Ms Tania Skelli
Haringey Planning Services
cc. Elisabetta Tonazzi, Conservation Officer
25th April 2023

**RE: Richards Music Centre, Highgate School, Bishopswood Road, London, N6
4PR- HGY/2023/0315**

First Floor Existing Area Plan

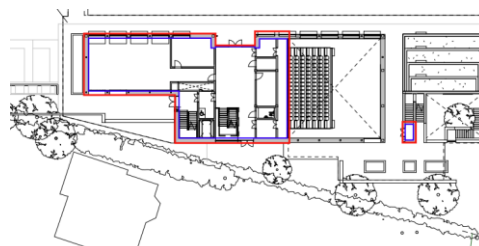
2. The proposed building is considerably larger than the existing one. Using the figures supplied by the applicant the new building is nearly three times larger. However, if one compares the floor area diagrams in the submission it becomes clear that the actual size is even greater, nearer four times the size, because the applicant has included the uninhabitable attic space in the existing building and excluded half of the ground floor of the new building because it is a void over the theatre.

Whilst they may well be technically correct according to RICS rules on measurement, the building that will be seen above ground level will be twice as big as the existing building with the same size again below ground level, an iceberg building virtually four times the size of the existing building. Why does the building need to be so big? Why does the school need a second performance space when there is already one in Dyne House? Why couldn't drama and music use the same communal facilities, maybe swapping the sixth form accommodation from Dyne House to the RMC where they would be nearer to the staff common room?
